**TITLE:** Continued Public Hearing - Main Street Marketplace – Major Site Plan Review, Conditional Use Permit, Request for Alternative Compliance and Variance

The Planning Commission considered this application at its September 27, 2018 meeting. At that meeting, the Commission discussed the Site Plan and Architectural Drawings. The Staff Report from that meeting is attached. This Staff Report discussed zoning and site plan review standards. There were three specific items which the Commission addressed as follows:

McDowell Engineering has reviewed the *Traffic Impact Analysis for Main Street Marketplace (TIS)* from Kimley Horn dated July 30, 2018. The study addresses the potential impacts of the proposed Main Street Marketplace development located on the northwest corner of State Highway 133 and Main Street. The Town should require additional clarification and a revised study from the applicant.

Roaring Fork Engineering (RFE) has reviewed the civil section of the planning level documents dated 7-30-2018 produced by Sopris Engineering and Kimley Horn. The review included the water, drainage, sanitary sewer and traffic study. The irrigation water allocations were not reviewed. RF

**Planting Plan**  
**Main Street Marketplace**  
 Lot 1, Carbondale, Colorado

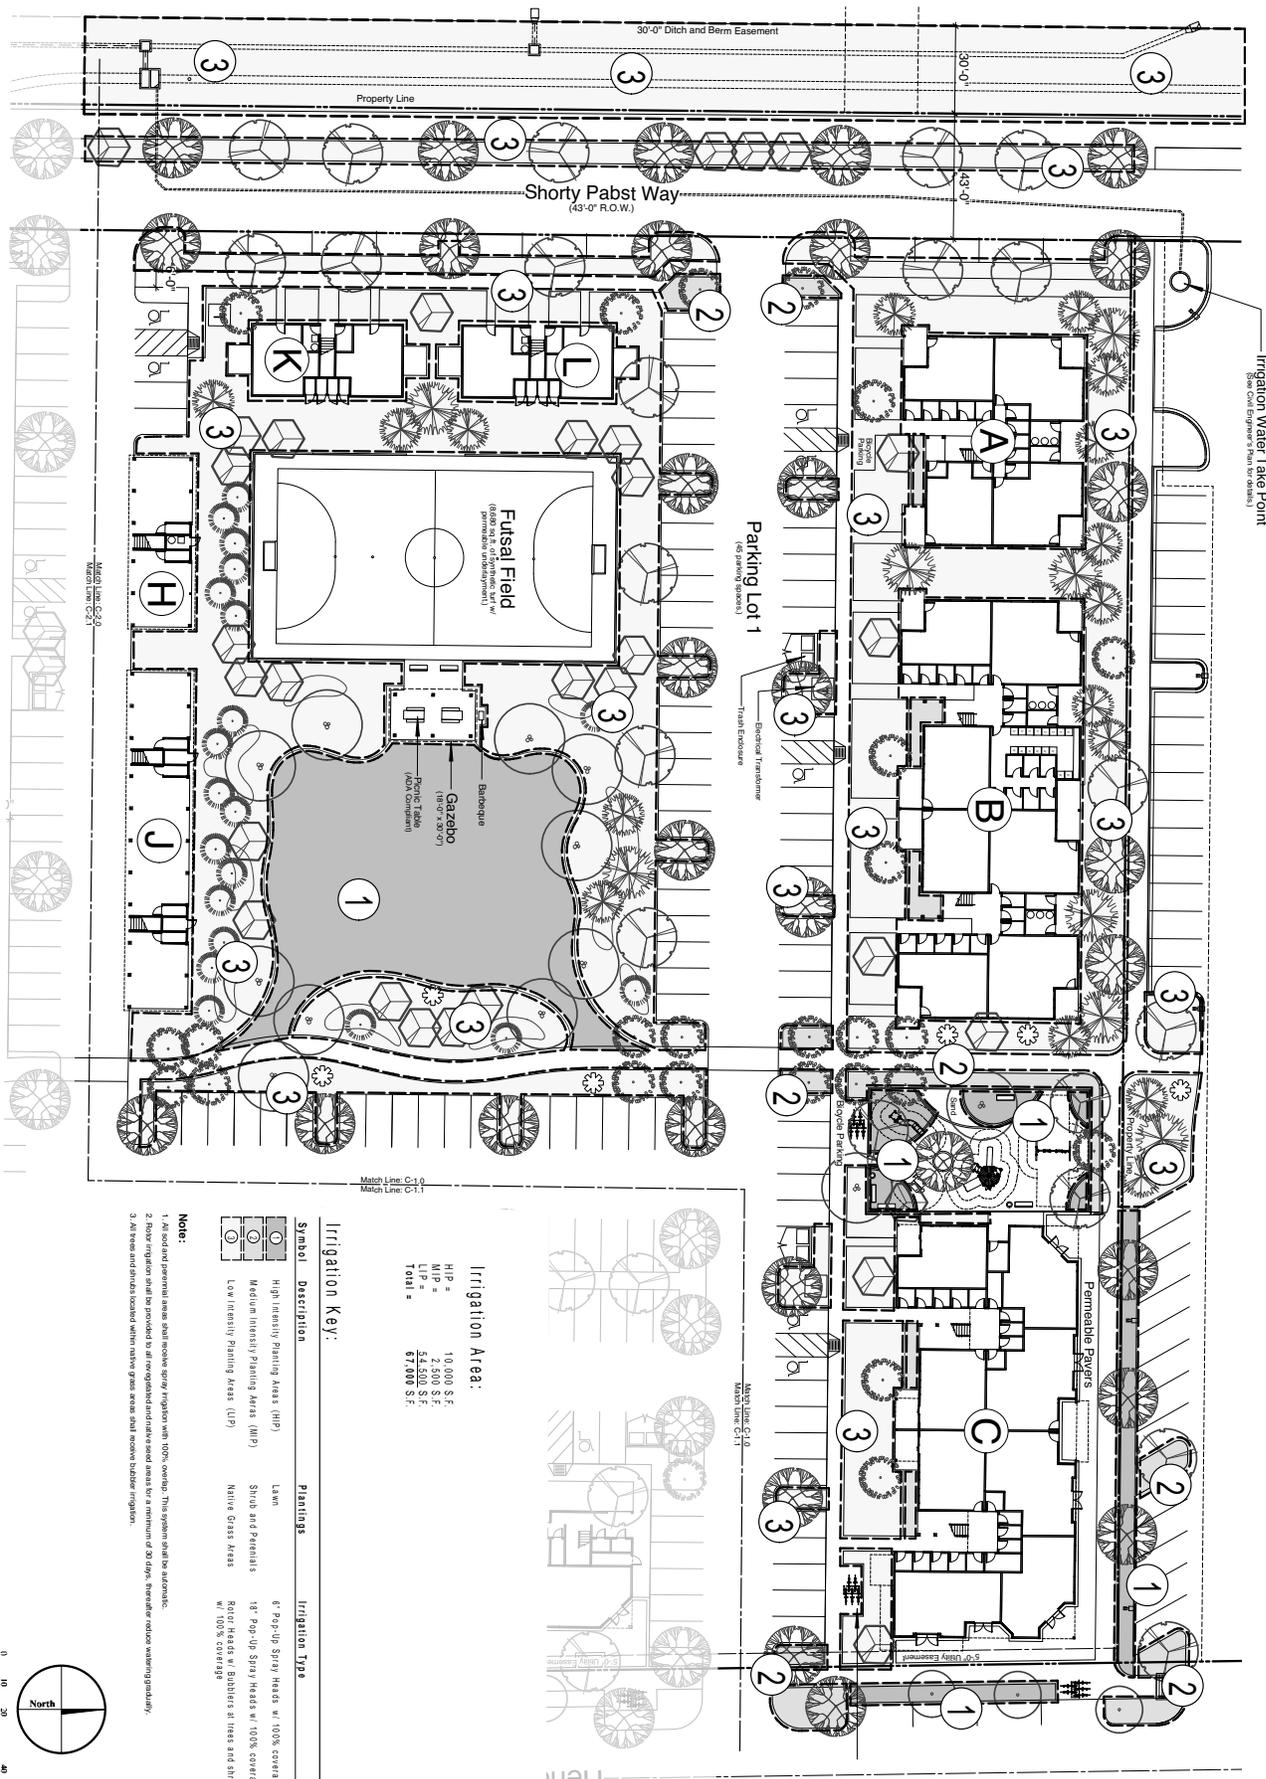
- Landscaping has been reviewed and generally complies with the UDC.
- The plant key needs to be revised to reflect a minimum 2.5" caliper.
